Subdivide existing 2 lots into 7 tracts and 75 lots, vacate easements and grant easements.

**Re: Sketch Plat Review for Proposed Subdivision of Tracts 12-B-1-A and 12-B-1-B of El Rancho Grande I**

**Sketch Plat for Solare Townhomes and Tracts 12-B-1-A-1 and 12-B-1-B-1**  
 El Rancho Grande I  
 Being Comprised of Tracts 12-B-1-A and 12-B-1-B  
 El Rancho Grande I  
 City of Albuquerque  
 Bernalillo County, New Mexico  
 January 2022

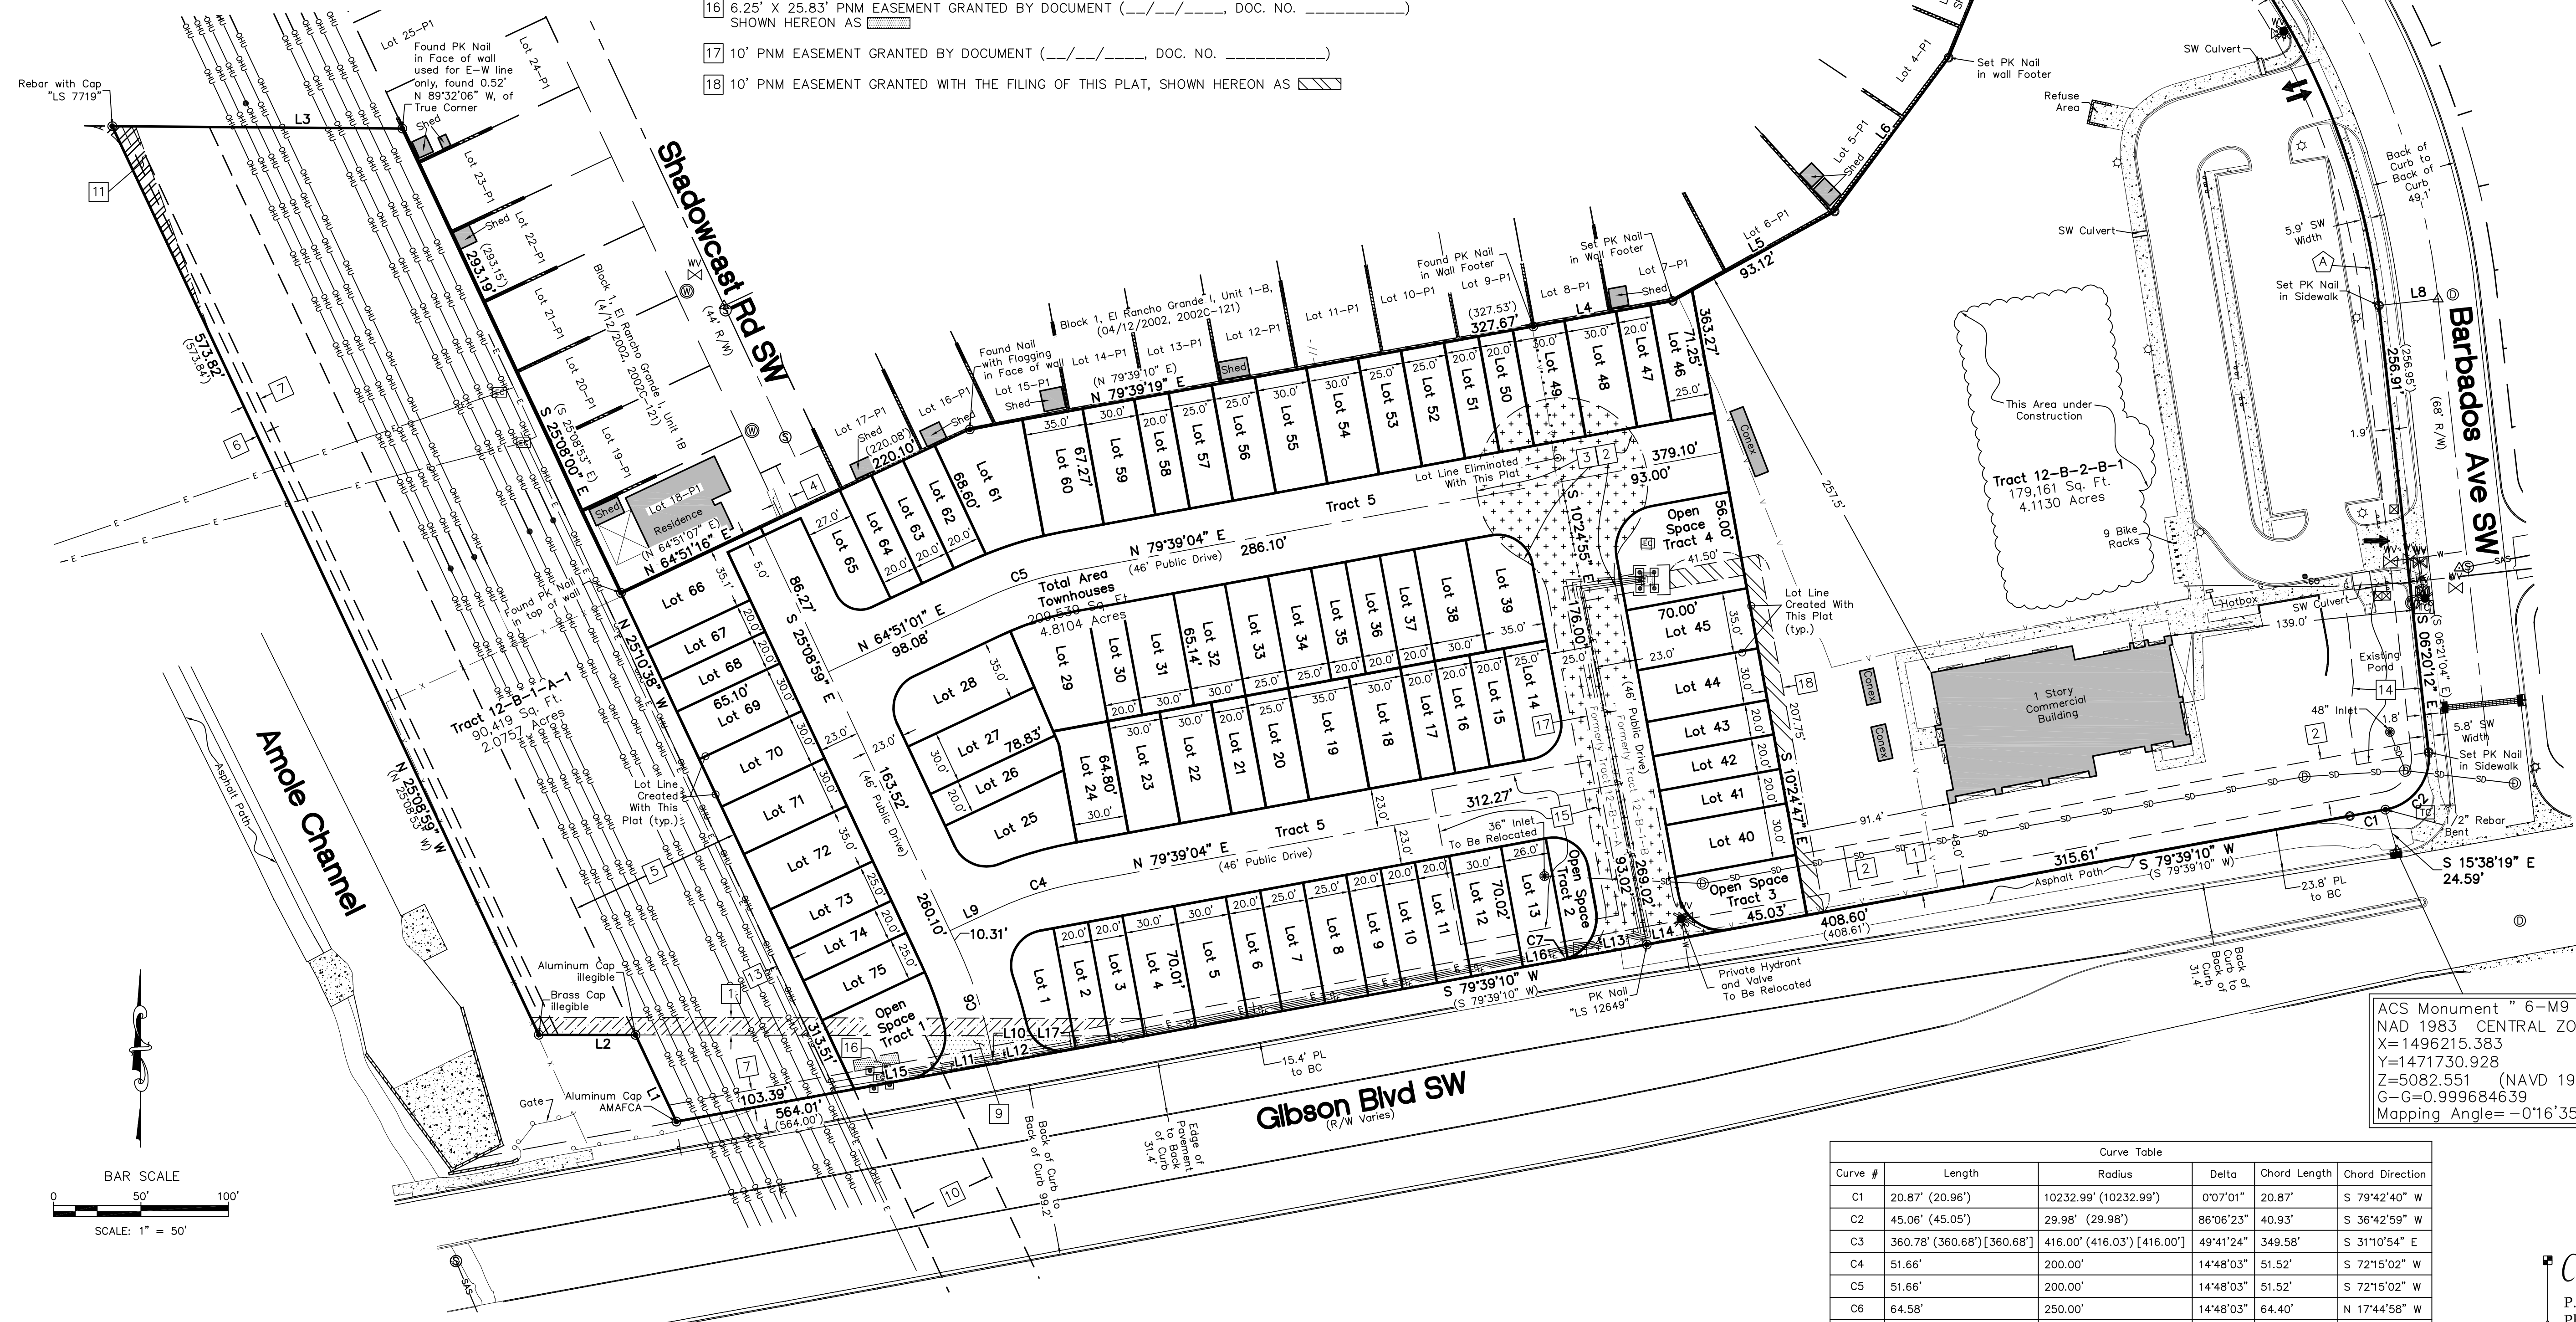
- Keyed note 4 shows a 10 foot wide pedestrian easement, but there appears to be a solid wall across the easement. Will a gate or similar be added?

**This keyed note is related to the developed properties to the north of this plat. The 10-foot pedestrian access easement was developed and is currently walled off with no access gate and located on private property.**

- Clarify the open space provided near Shadowcast Road, it is an odd shape and may not be useful.

**That space was eliminated with the stub street on new layout of subdivision.**
